OFFICIAL NOTICE AND AGENDA

1. Call to order
2. Consider approval of the Business Park North minutes of July 9, 2018.
3. Request by Mike Kohlbeck for approval of a building addition at Dairyland Electric, 340 Business Park Circle.
 - Recommendation to Plan Commission
4. Future agenda items
5. Adjournment

Proposed Building Addition Project Narrative:

I have completed a final review of the proposed building addition for Dairyland Electric at 340 Business Park Circle. The building addition is proposed to add 3,409 square feet of additional office space. As noted, additional information may be required to be provided or shown on the plans.

PROPOSED ADDITION FOR:
DAIRYLAND ELECTRICAL INDUSTRIES, INC.
PROPOSED SITE PLAN

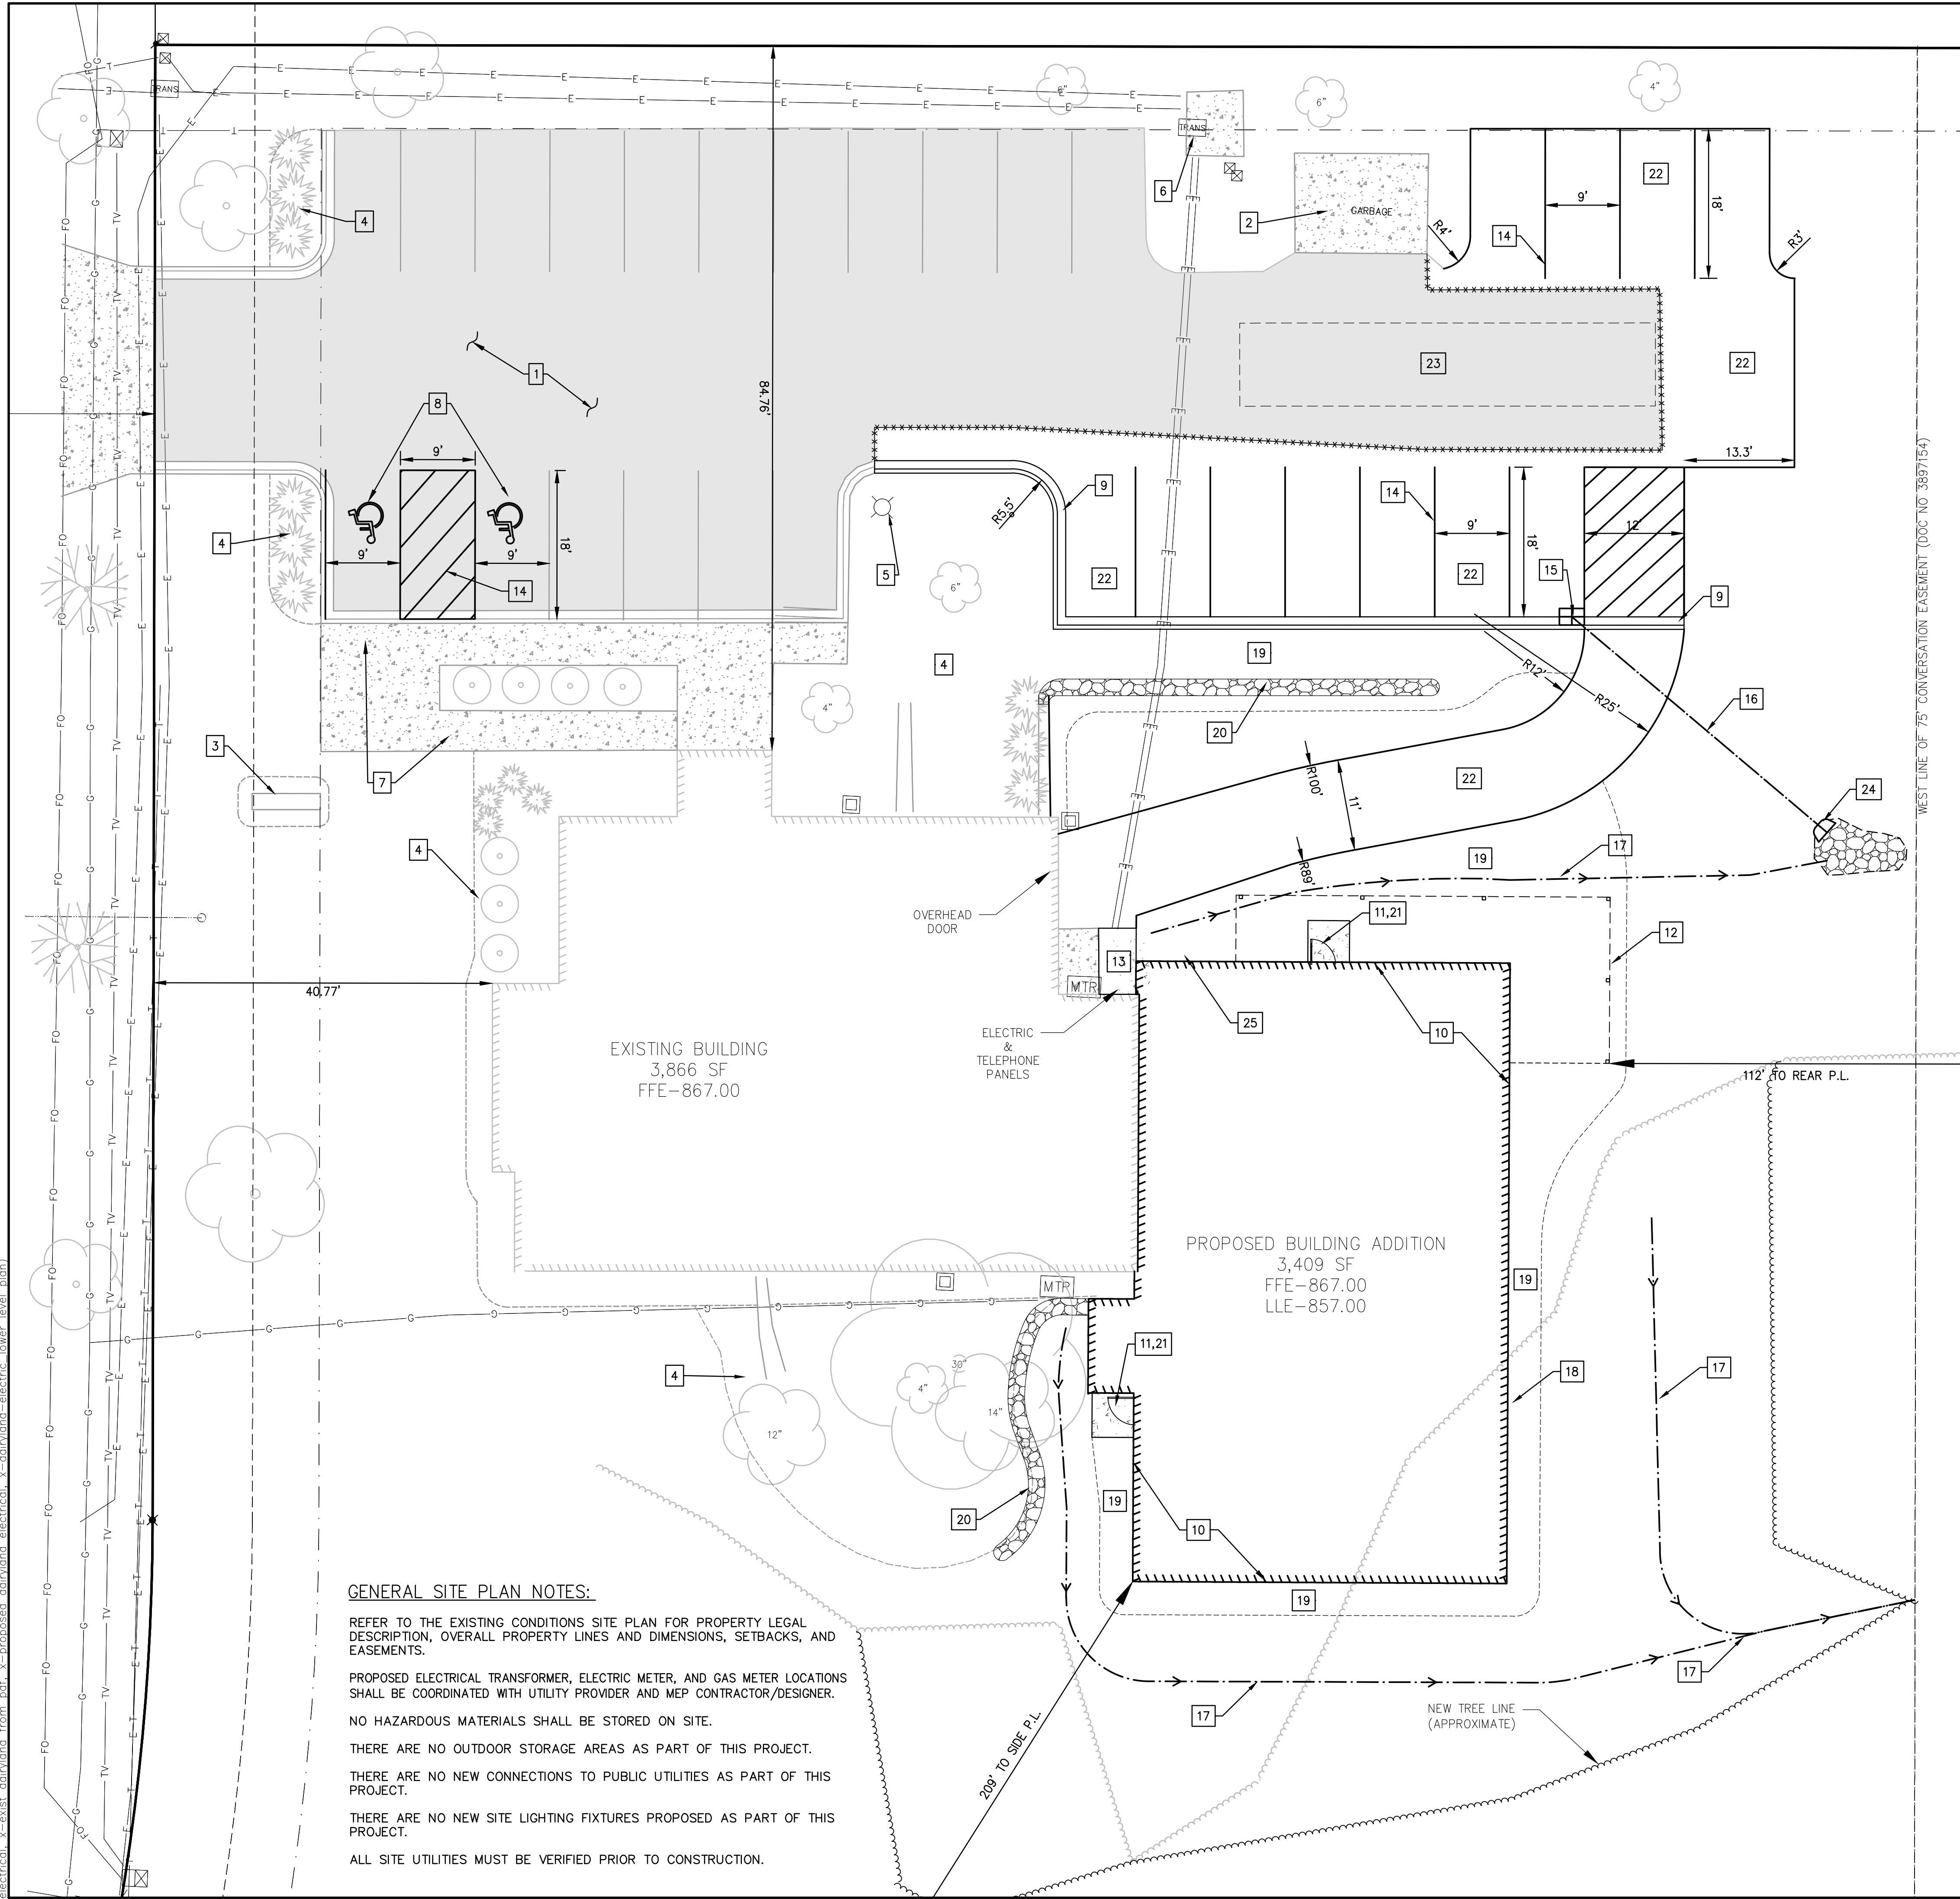
2. The Comprehensive Plan, Future Land Use Map designates this property as Planned Industrial which is consistent with the zoning and existing uses.
3. The parking requirement for an office land use is one space per 300 square feet of gross floor area. **26 parking spaces are required while 28 are proposed.**

4. The proposed building addition meets the setback and height requirements of the Planned Industrial district. (Min front yard setback – 20 feet; Min side yard setback – 10 feet; Min rear yard setback – 20 feet; Max building height – 40 feet) **The plan meets these requirements.**

8. Per section 78-704 (13)(a), bicycle parking is required equal to 10% of the automobile parking space requirement. There are specific requirements related to bicycle parking in section 78-704 (13)(c). **This requirement pertains to the newly added parking. Two bike stalls are provided.**

10. The minimum landscape surface ratio (LSR) is 25 percent. **The plan meets this requirement.**
11. A landscaping plan which meets the requirements of section 78-604 must be provided for the building addition and added pavement area. **The proposed landscaping meets these requirements.**

PROPOSED ADDITION FOR:
DAIRYLAND ELECTRICAL INDUSTRIES, INC.
LANDSCAPE PLAN

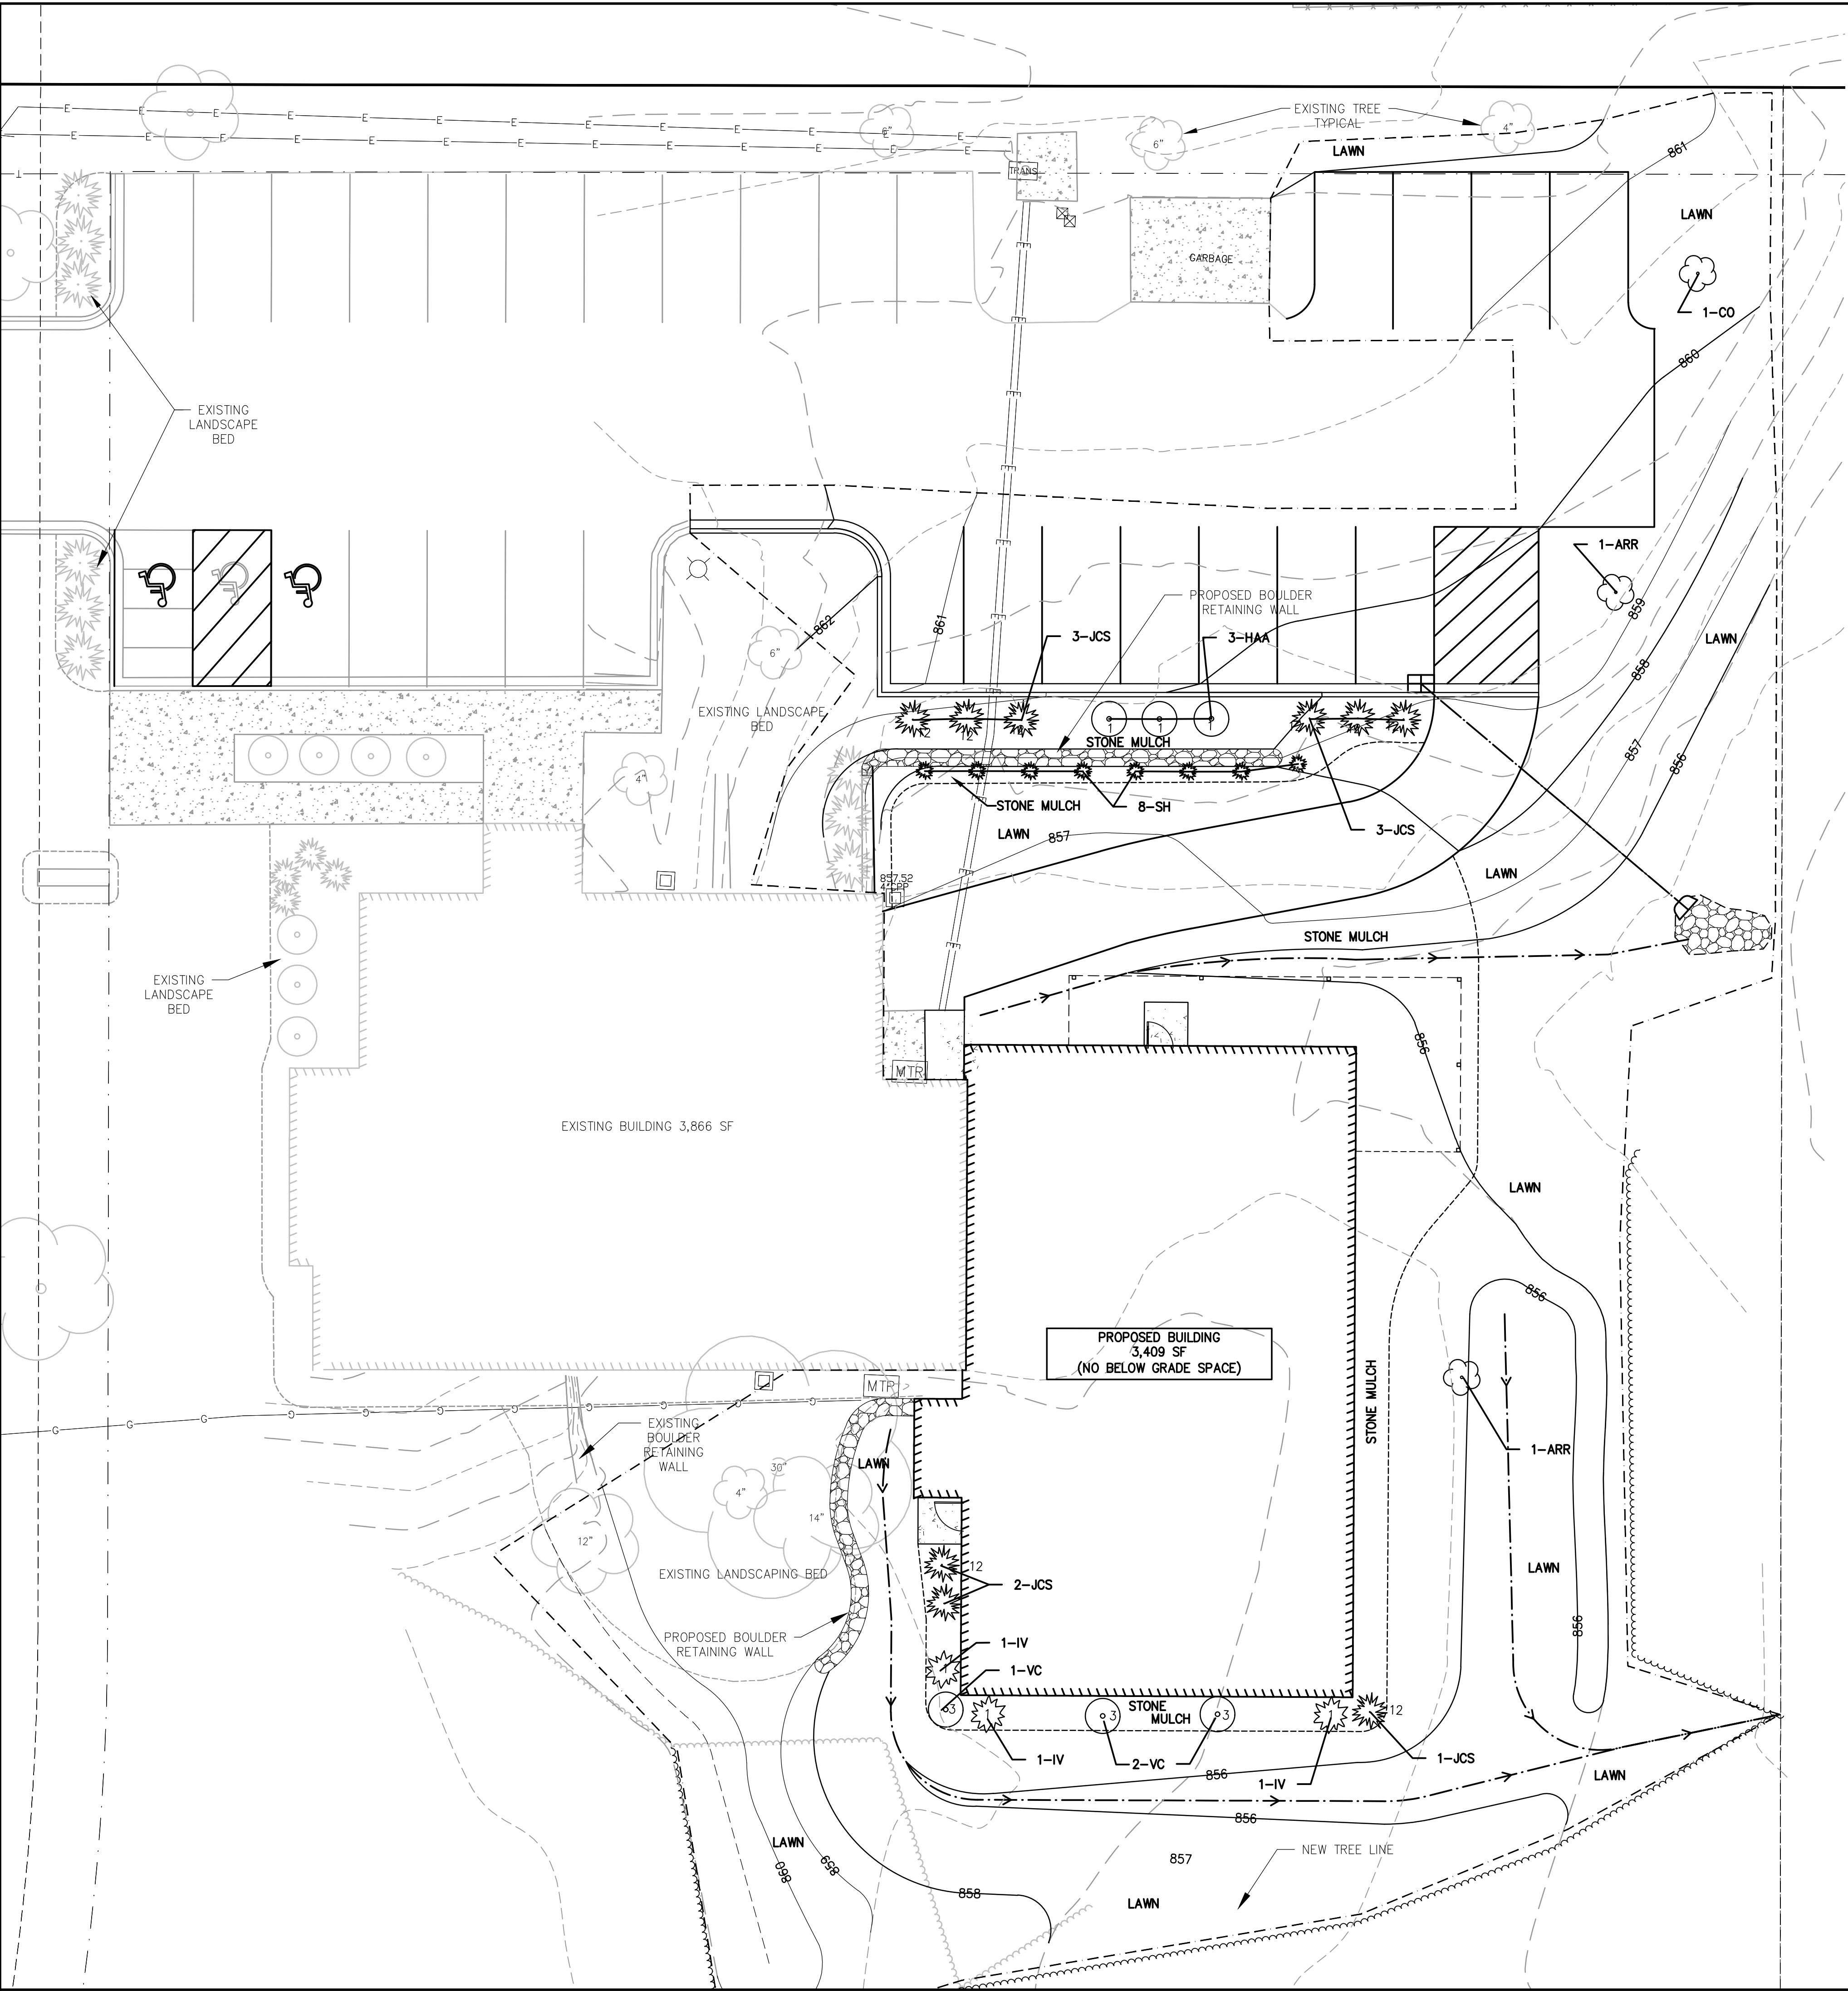
- g. “Areas used for parking shall be landscaped and/or fenced in such a manner as to interrupt or screen said areas from view of access streets, freeways, and adjacent properties. Plant materials used for this purpose shall consist of lineal or grouped masses of shrubs and/or trees.” **Meeting the zoning code requirements will sufficiently meet this requirement which is consistent with previous approvals.**
